Form C-103
Revised July 18, 2013

7. Lease Name or Unit Agreement Name ARGO	
8. Well Number 14	
9. OGRID Numer 873	
10. Pool Name or Wildcat PENROSE SKELLY; GRAYBURG	
SUNDRY NOTICES AND REPORTS ON WELLS (DO NOT USE THIS FORM FOR PROPOSALS TO DRILL OR DEEPEN OR PLUG BACK TO A DIFFERENT RESERVIOR. USE "APPLICATION FOR PERMIT" (FORM C-101) FOR SUCH PROPOSALS.)

Apache Corporation proposes to P&A the above mentioned well by the attached procedure. A closed loop system will be used for all fluids from this wellbore and disposed of required by OCD Rule 19.15.17.14 NMAC.

Operator: APACHE CORPORATION 303 Veterans Airpark Ln Midland, TX 79705	OGRID: 873
	Action Number: 168803
	Action Type: [C-103] NOI Plug & Abandon (C-103F)

LEASE NAME	ARGO
WELL #	14
API #	30-025-39828
COUNTY	LEA

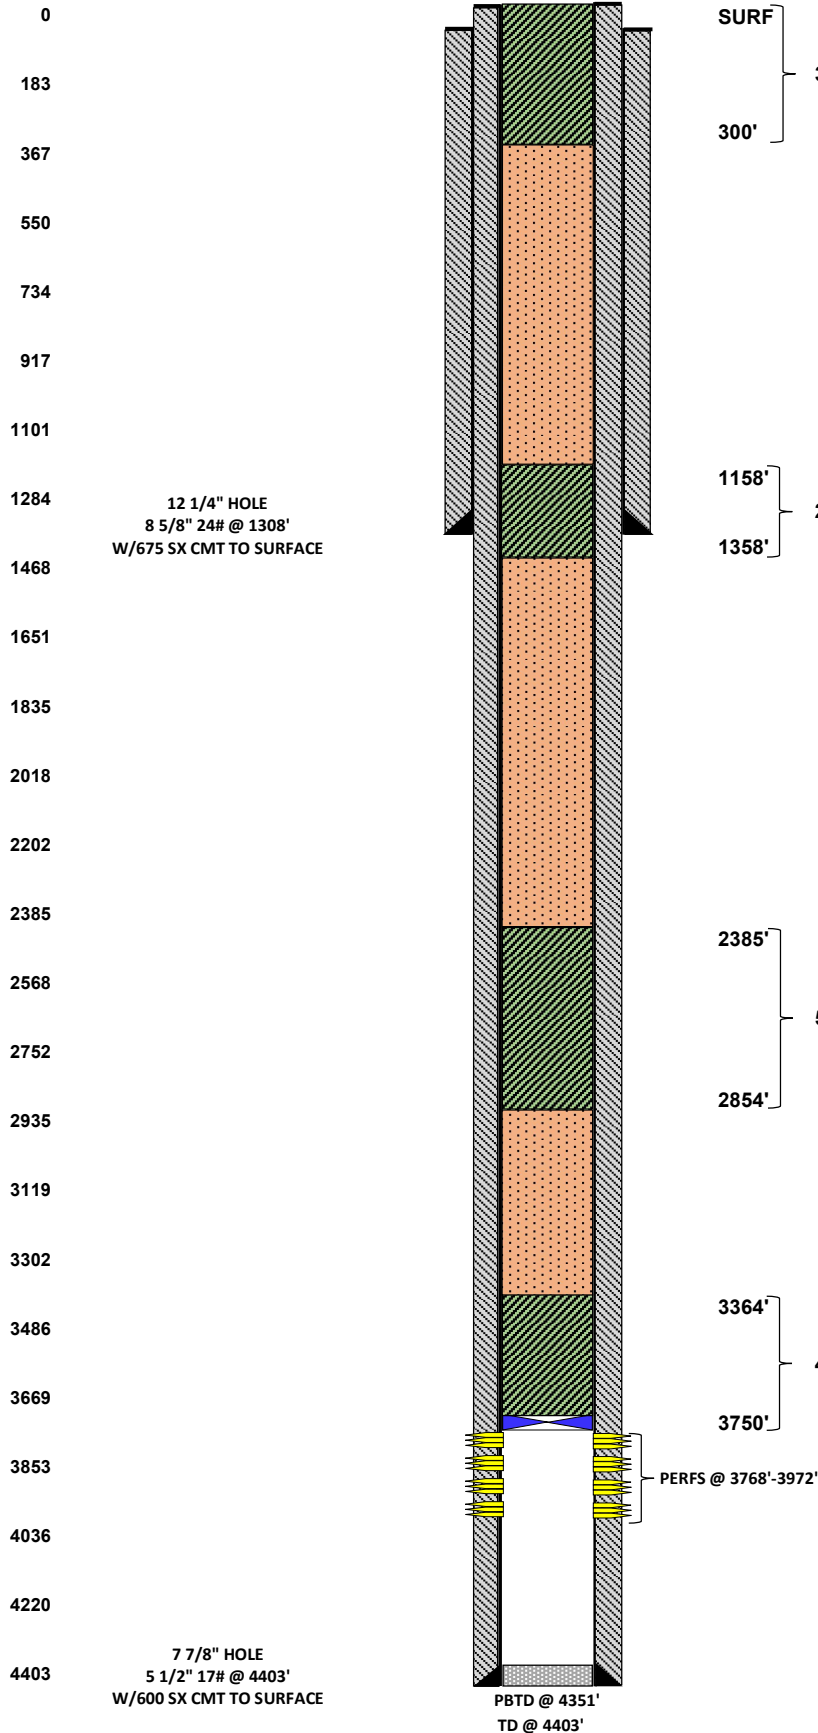
LPC Area Below ground marker send pics before backfilling hole

SEE ATTACHED CONDITIONS OF APPROVAL
